TO: Jeff Weeder, Galloway and Company
FROM: Amber Wood Hicken, Planner I
DATE: 1/26/23
SUBJECT: Lincoln Professional Park L3 – Andy’s Custard, Site Plan Review Comments 02

ANDY'S FROZEN CUSTARD PARKER, COLORADO

2 BUILDING ELEVATION - NORTH FACE (E. 40TH AVE) 1/4" = 1'-0"

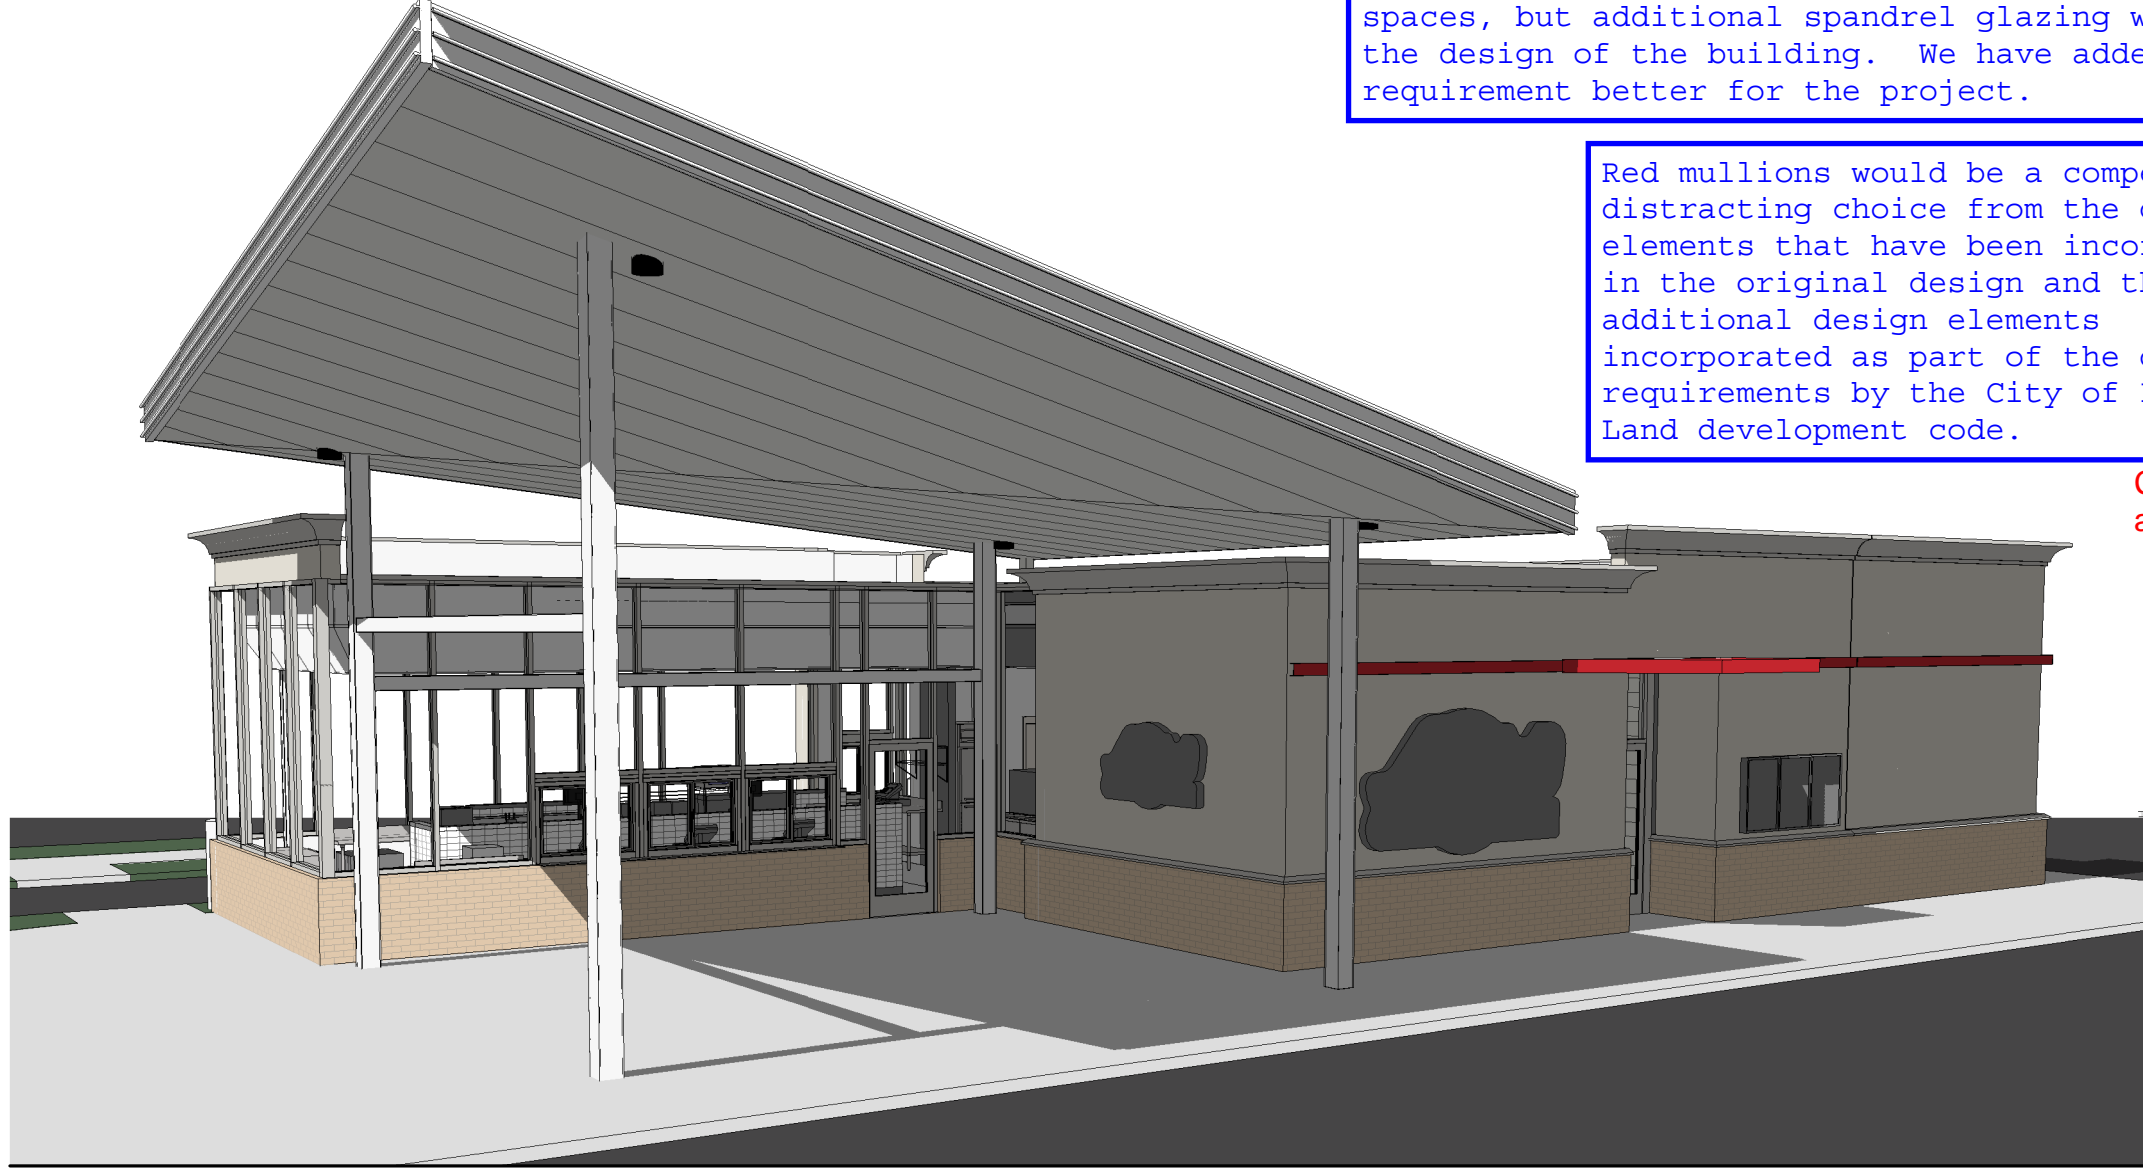
Add title to all pages

Exterior lighting must be shown on the elevations 13.06.030 (c)(6)(b)

Could the mullions also be red?

Design guidelines specify 40% Pg 50

Can the red color be added to this element to create an architectural feature?

Per Design Standards pg 59, Use the brick to encase these posts to meet the architectural requirements

Vary up this portion of the building with a variety of color, materials, and architectural elements

Greater horizontal articulation (plane breaks) needed

Title has been added to all pages.

Lighting has been added to elevations.

A different color has been chosen.

Adding red to the canopy is similar to the red mullions in that it will be distracting and competing with the design elements already developed for the project.

Adjusting the percentages of the materials to include more glazing would need to be spandrel glazing to protect the privacy and security of the workers inside the store. We feel the design in concept does work to meet the intent of the code to provide transparency to the front of house spaces, but additional spandrel glazing would look inconsistent and would not provide better to the design of the building. We have added another boxnote to help understand the transparency requirement better for the project.

Red mullions would be a competing and distracting choice from the design elements that have been incorporated in the original design and the additional design elements incorporated as part of the design requirements by the City of Parker Land development code.

Brick Pilasters have been added to the canopy columns

No such roadway in Parker
This has been corrected.

The columns have been wrapped at the base.

Decorative cornice, varied parapet heights, material transition watertable, additional glazing on the non-primary facades to the function of the building, additional recesses/projections on the drive-thru and rear facing fades are all previous additions to the design. We have also added a diamond pattern to the stucco material for additional varied interest on the facades as part of these revisions. We feel that further enhancements or the use of colors over the five already introduced for the size of the building is not recommended.

Sheet Number: R002

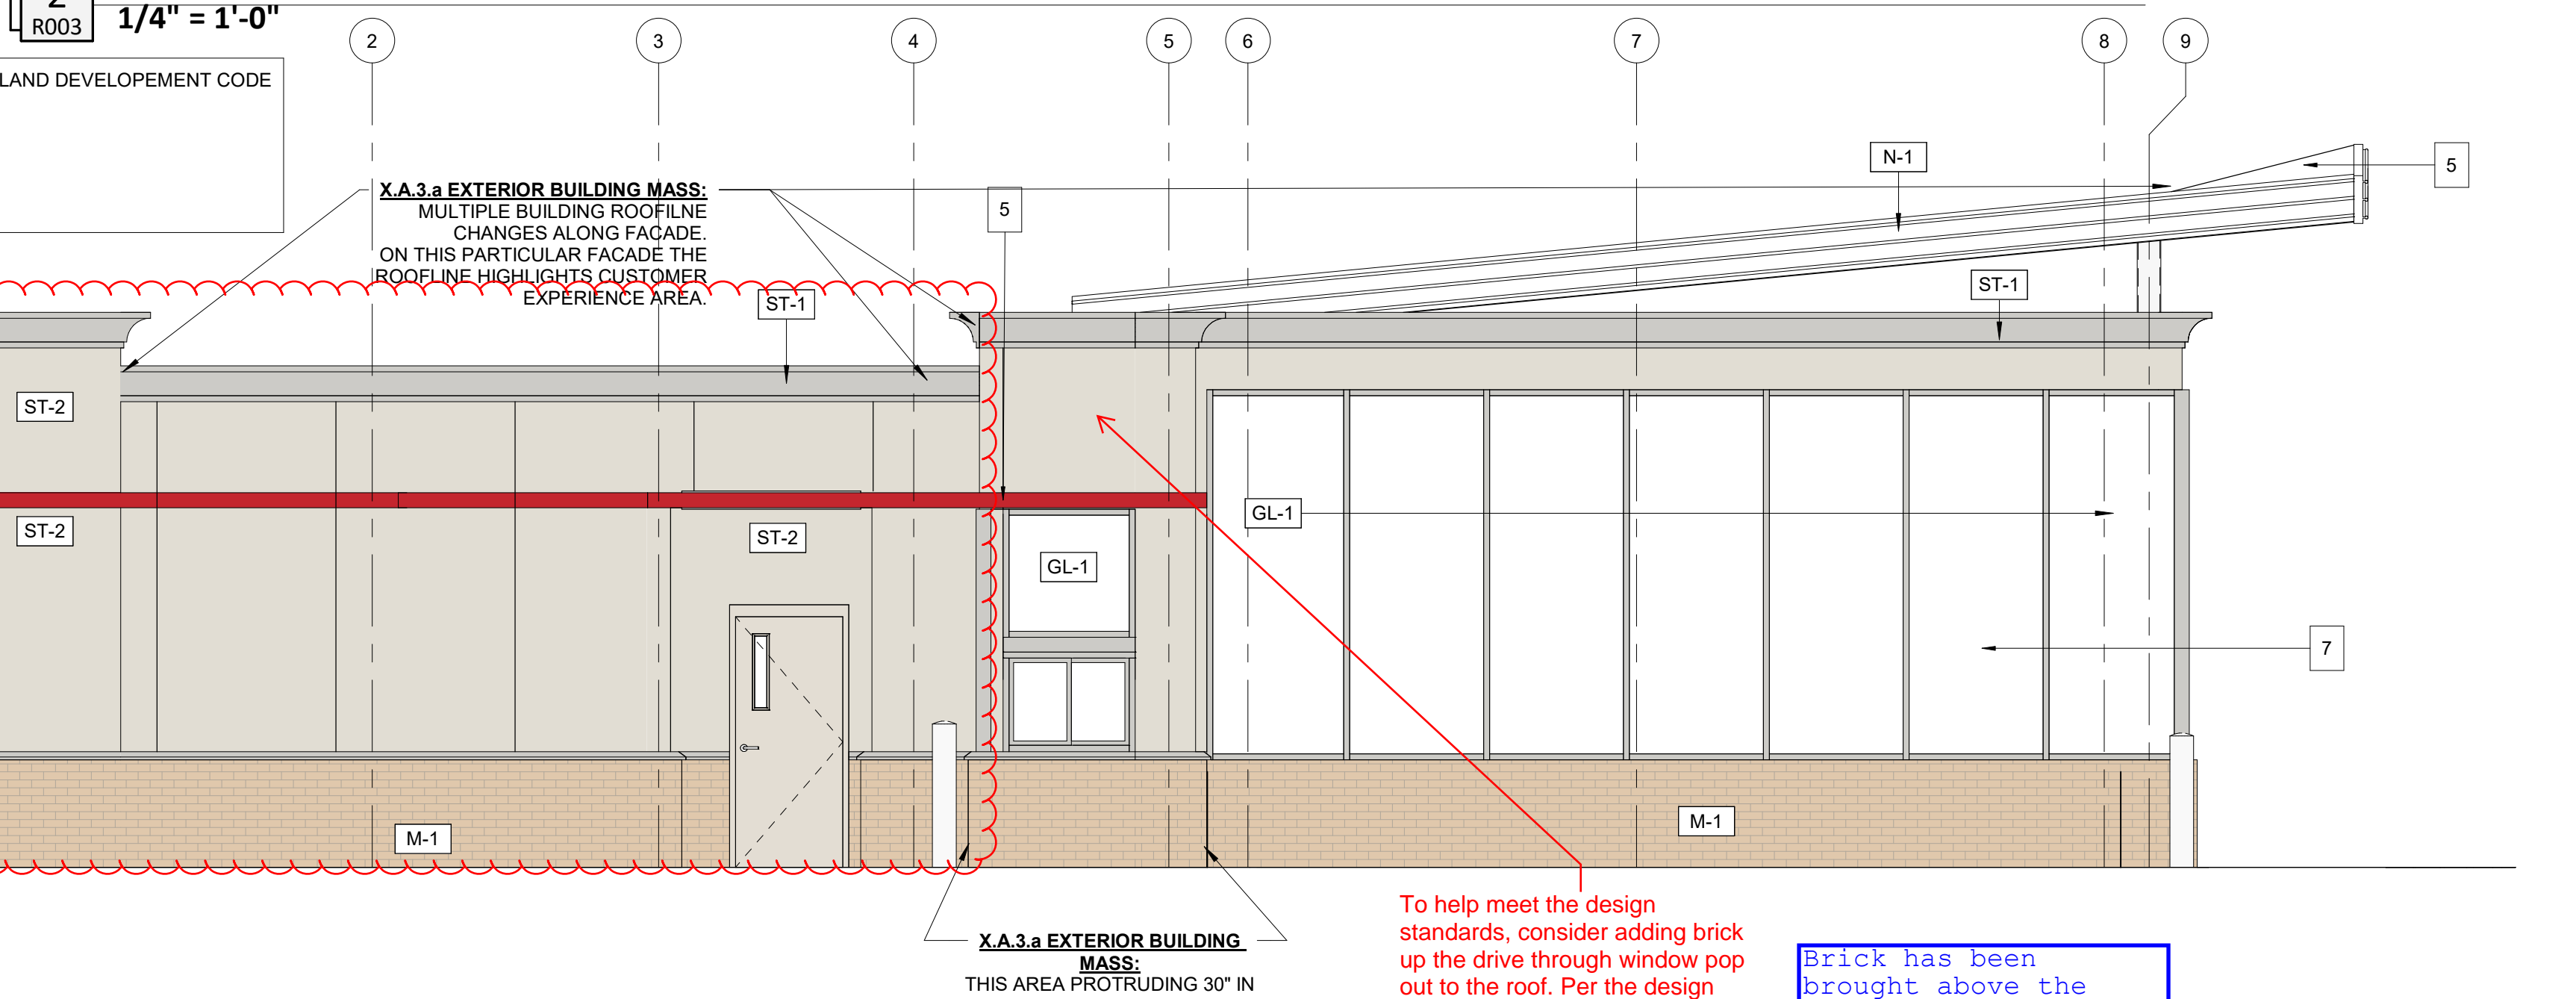
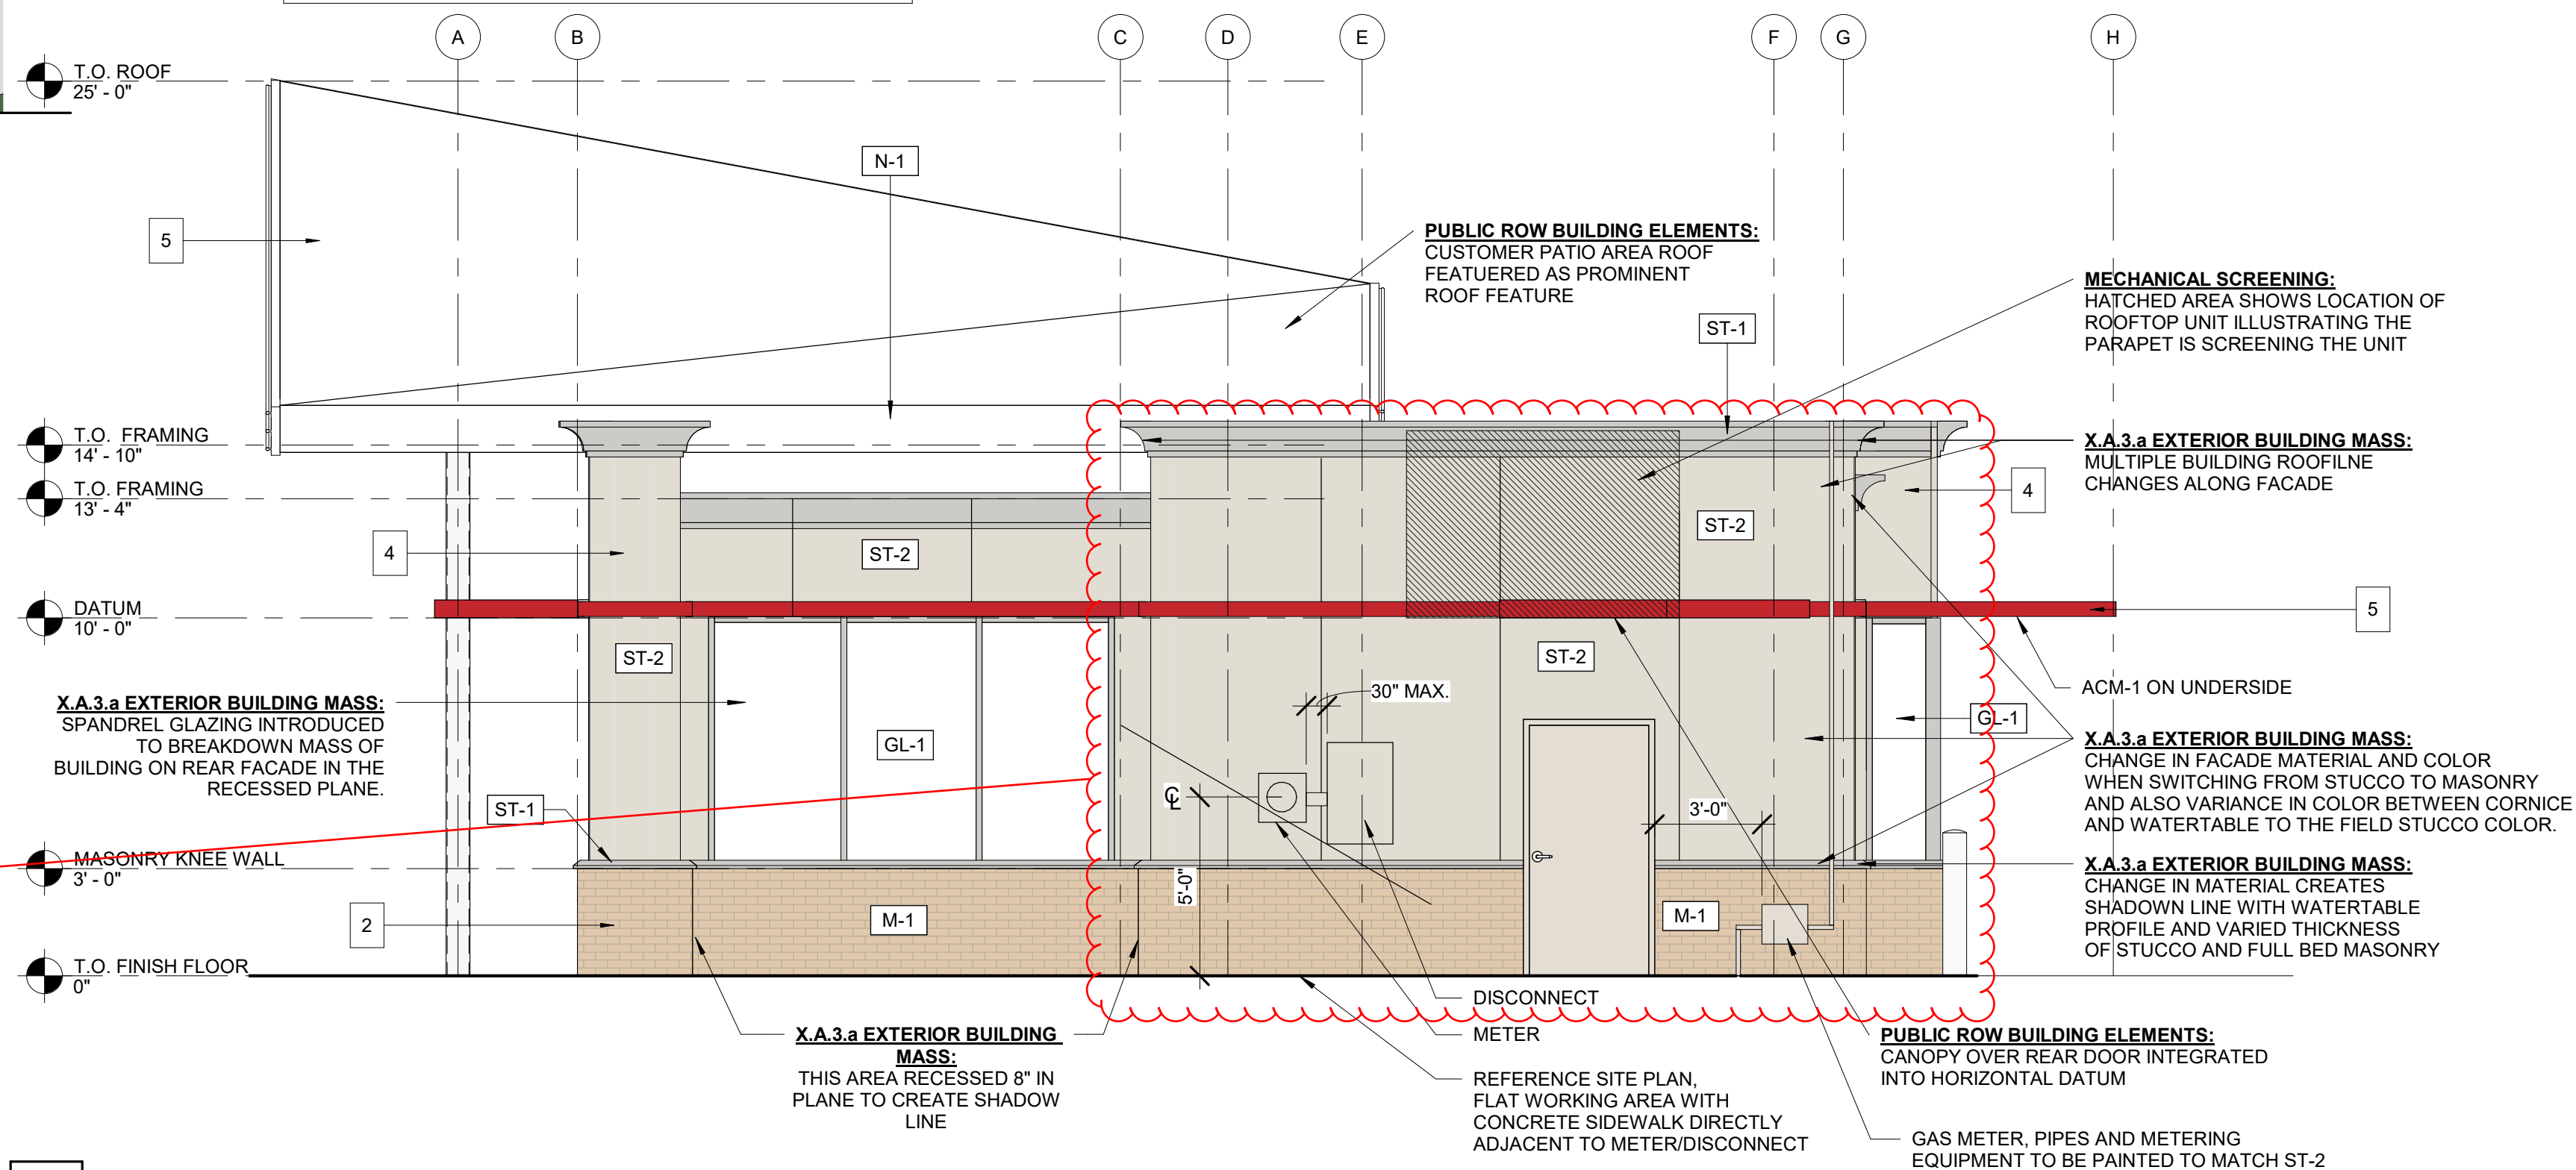
Add title to all pages

Vary up this portion of the building with a variety of color, materials, and architectural elements. Greater horizontal articulation (plane breaks) are also needed.

Please label materials for awnings and canopies.

To help meet the design standards, consider adding brick up the drive through window pop out to the roof. Per the design standards, 3 elements are needed to provide vertical mass relief. The three can be found on page 53. This building is not meeting the intent of the 1st element, regarding changes in plane.

Title has been added to all pages.

Decorative cornice, varied parapet heights, material transition watertable, additional glazing on the non-primary facades to the function of the building, additional recesses/projections on the drive-thru and rear facing fades are all previous additions to the design. We have also added a diamond pattern to the stucco material for additional varied interest on the facades as part of these revisions. We feel that further enhancements or the use of colors over the five already introduced for the size of the building is not recommended.

A label has been added for the awnings and canopies.

Brick has been brought above the drive thru window
